# ORM PROCESSING SHEET

Applicant Terrebonne Levee & Construction District Agent \_\_\_\_\_  
South Lafourche Levee District  
Description dredge and place material to refurbish pipeline levee

Proj. Manager Bobby Quebedeaux PM Code WJL Parish Terrebonne, Lafourche  
Permit No. MVN-2010-01549-055 (Ex.: MVN 2004-2159-CY)

**From:** Quebedeaux, Bobby D MVN  
**Sent:** Wednesday, July 14, 2010 12:12 PM  
**To:** 'Jerome Zeringue'  
**Cc:** Duke, Ronnie W MVN; Serio, Pete J MVN; 'Karl Morgan'  
**Subject:** EUA - 10 073, Twin Pipelines Dredge and Fill

PHASE IV - CATFISH LAKE TO GOLDEN MEADOW

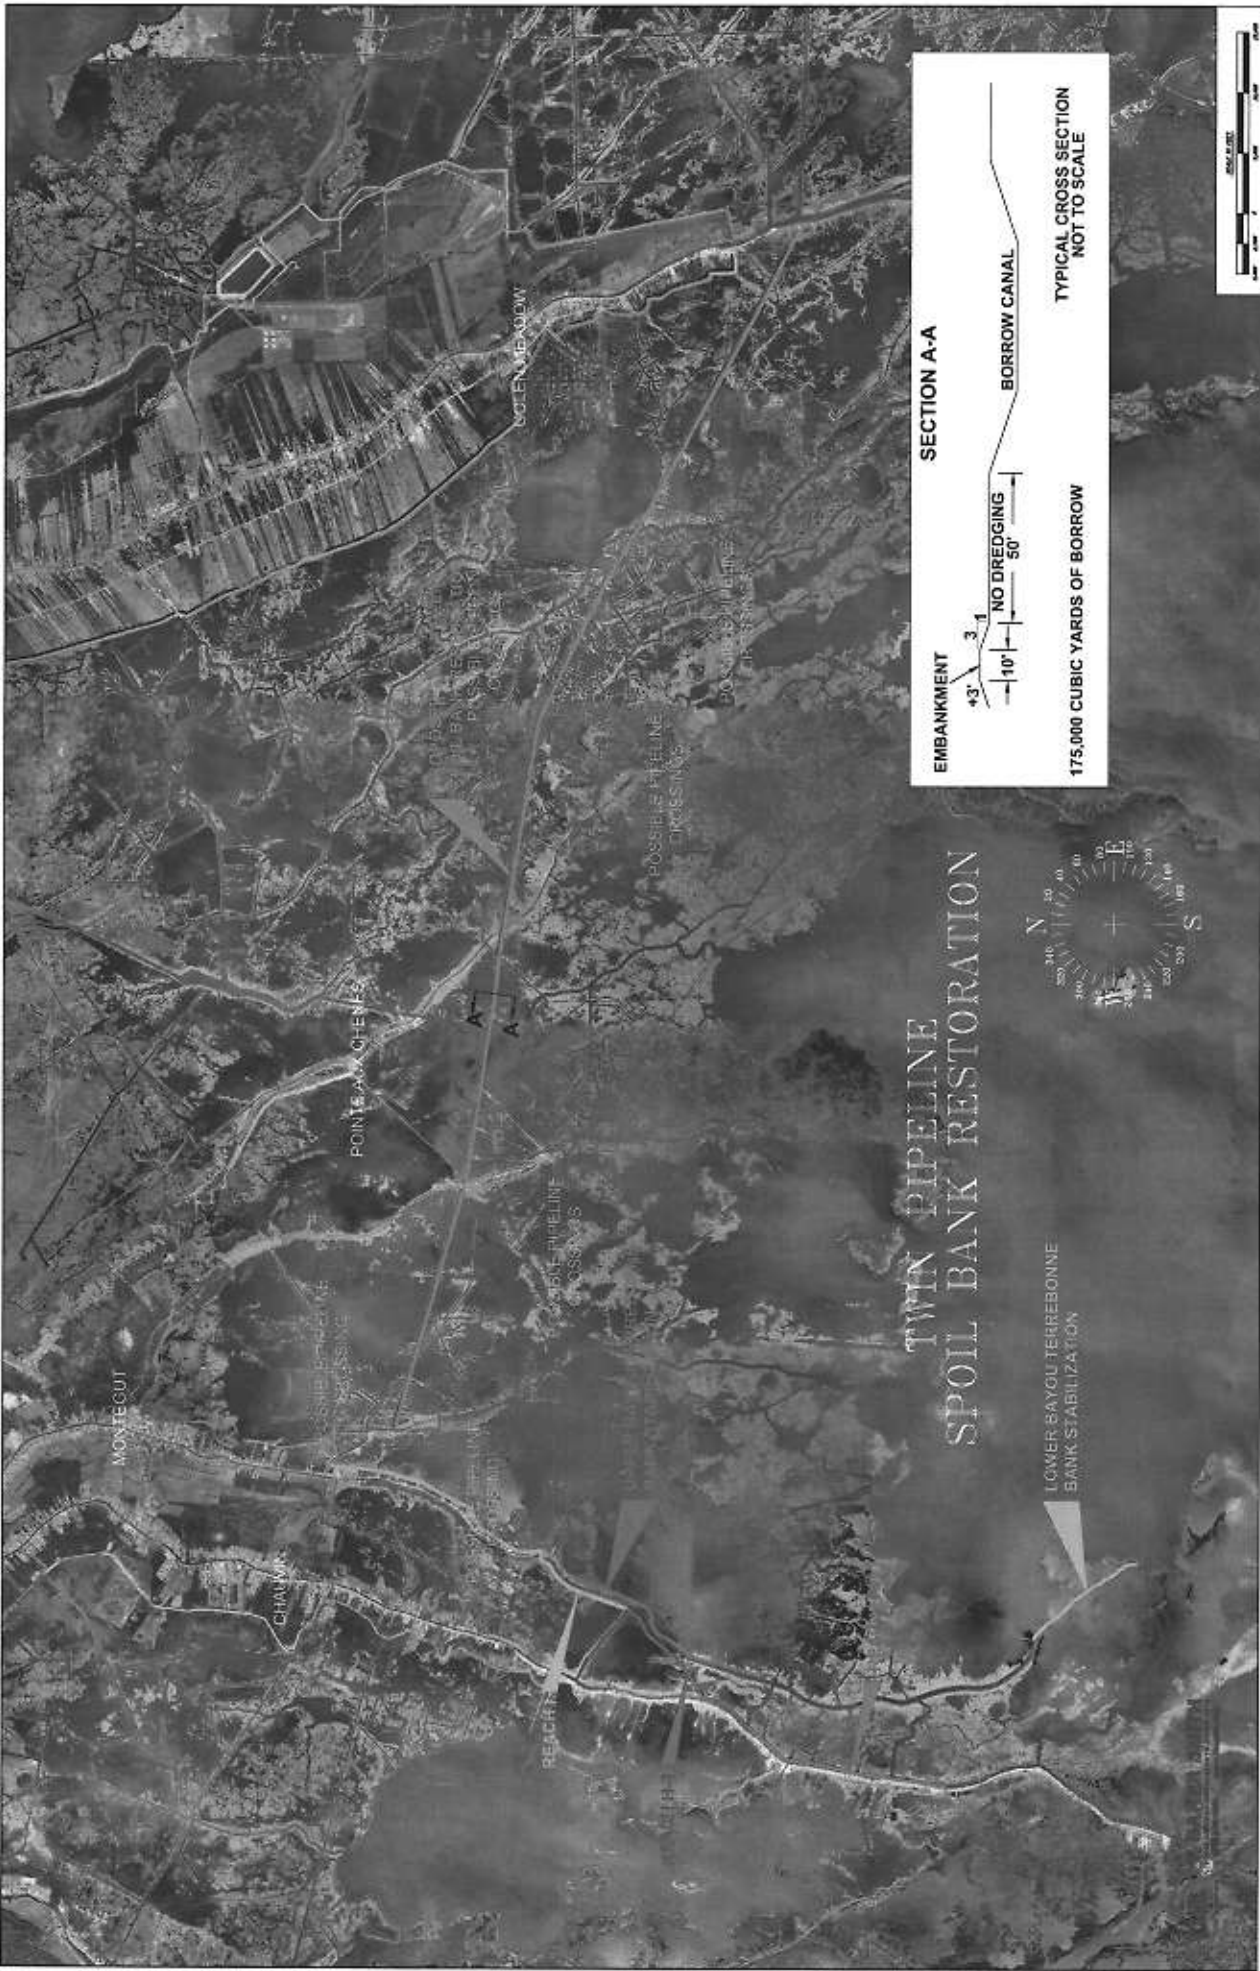
- We question the efficacy of the proposal to reduce oil intrusion particularly for the vicinity around Catfish Lake. Years of reconnaissance level investigation of this area to assess coastal restoration alternatives that would reduce flow across the Twin Pipelines suggests that substantial flow occurs through the oil and gas canals west of Catfish Lake and through Grand Bayou Blue. Undeniably, the proposal would reduce

PHASE I - MONTEGUT TO ISLE JEAN CHARLES

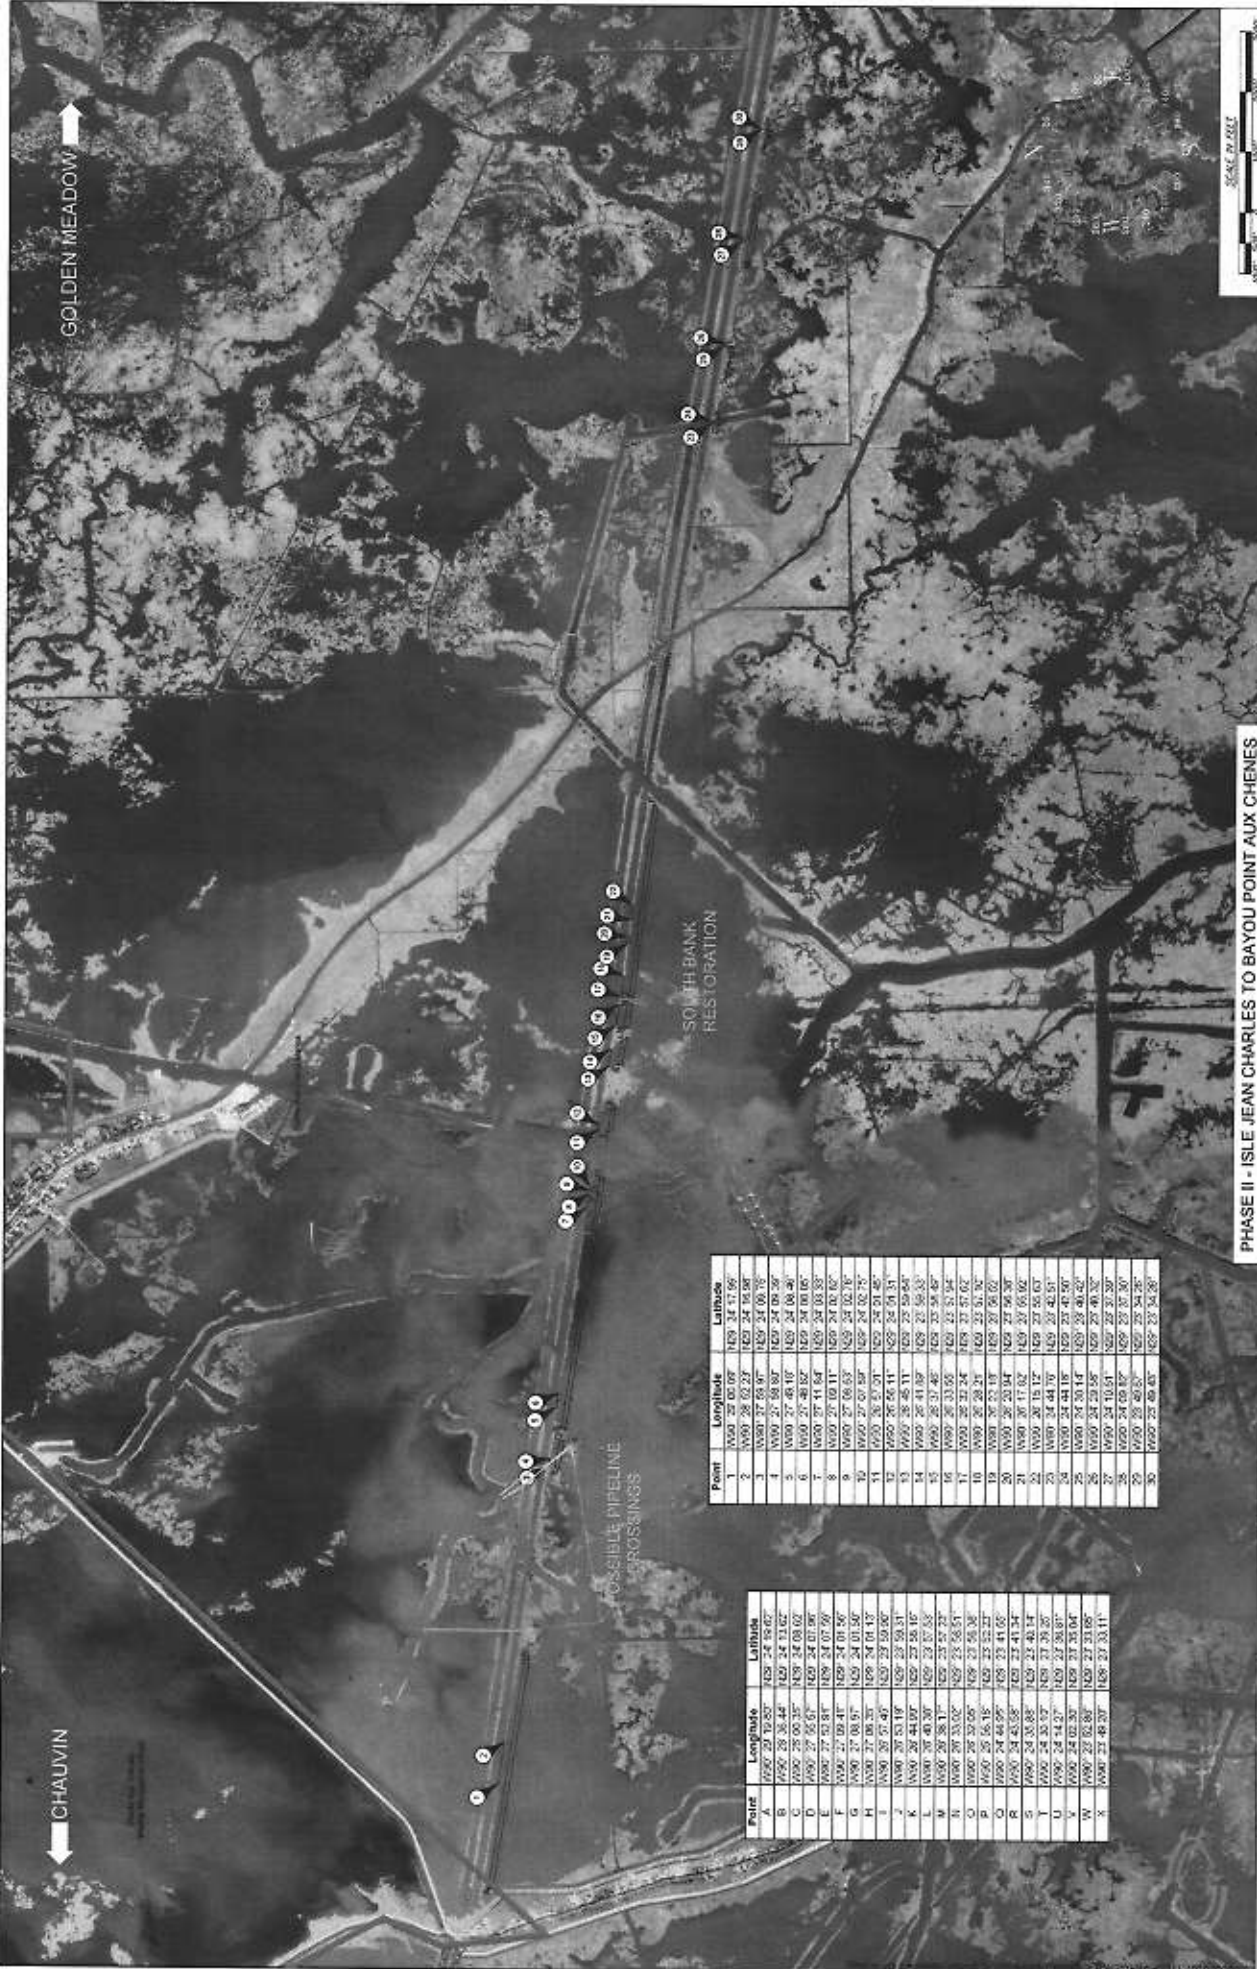
We are still waiting for answer to the question about specifically where will the drag line be used and specifically where will the marsh buggy be used. We need plats that show the route each type equipment will access each work site.

Have the applicants considered excavating the other spoil banks in order to create the plugs for the southern spoil bank? Please consider this option, in order to avoid existing pipelines, and provide a justification for not using the existing spoil banks for fill.

Graphic representation on the plan view of where the excavation will occur.

I reviewed the drawing that were sent out from this office by Mitch Marmande. The marsh buggy dragline will work on the 50' berm (section A-A). The borrow site is to the south and the spoil will be placed on the southern most spoil bank. Where gaps cannot be contained with dredged material booms will be used to bridge the gap.

In response to the email from Harmon Brown, I have prepared the attached maps to detail the exact locations of the fill and excavation areas. Contained on this plan view is a table which references by number the location of the fill areas (beginning and end points) and by letter the excavation areas (beginning and end points).
